## 2.2 Design Review Process

## 2.3 Key Design Changes

Fig. 31. Market Street connection options by ASPECT Studios (Conceptual illustration only - subject to design competition)

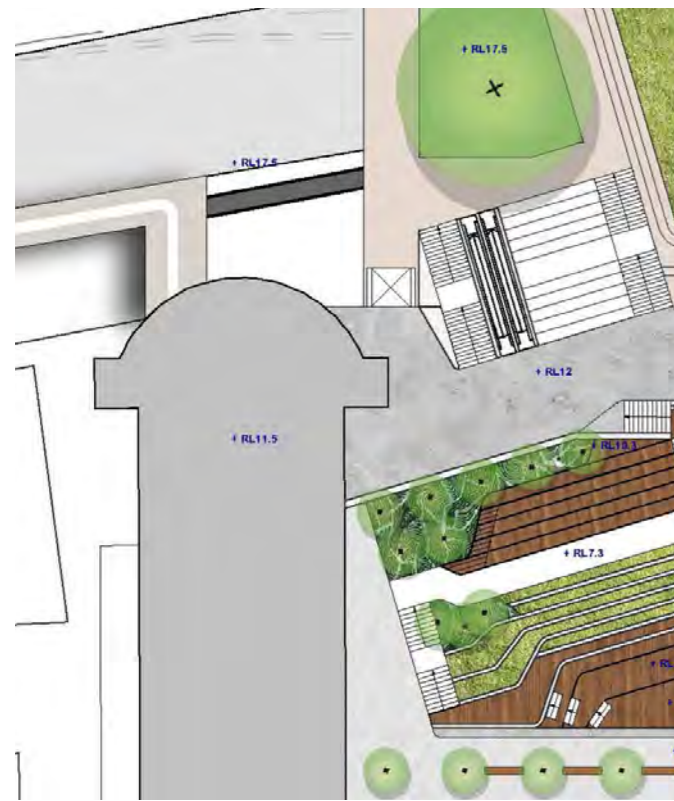
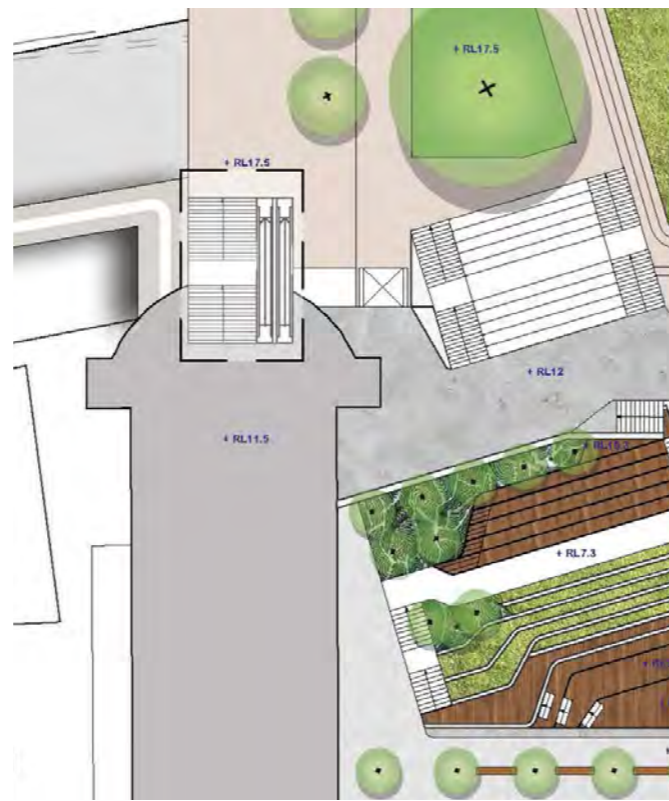
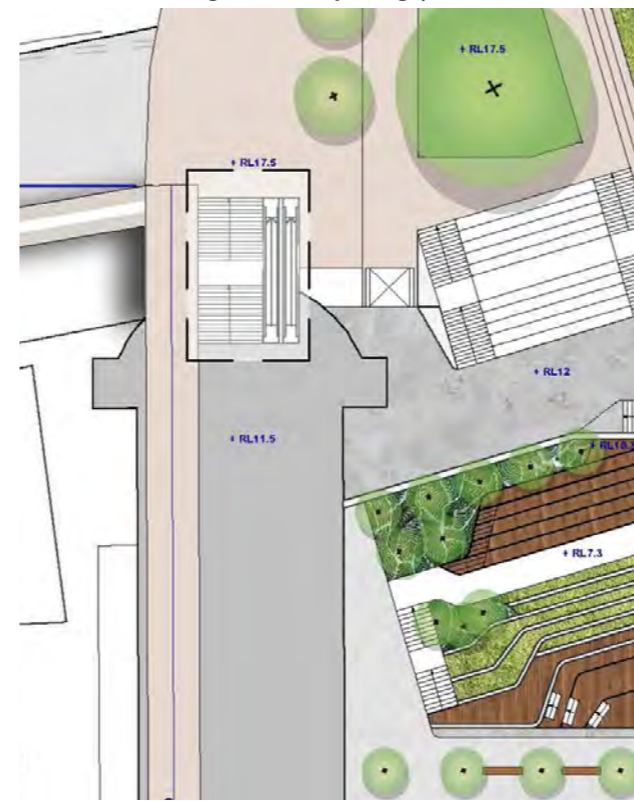
- The proposed pedestrian bridge extending from Market Street/Darling Park over the eastern section of the Pyrmont Bridge does not acknowledge the form and fabric of the bridge
- Any pedestrian link to Pyrmont Bridge must be physically/structurally separated to the bridge structure

1. Lift, escalators and stairs to landing beside bridge

2. Stair and escalators landing on Pymont Bridge

3. 1:20 accessible ramp, 4m wide and 90-120m long with landing on Pymont Bridge. Access to King Street cycling path retained.

- Heritage impacts on Pymont Bridge
- Option 2 is proposed to be adopted as it provides a reduced impact on Pymont Bridge whilst maintaining an improved direct connection to Market Street.
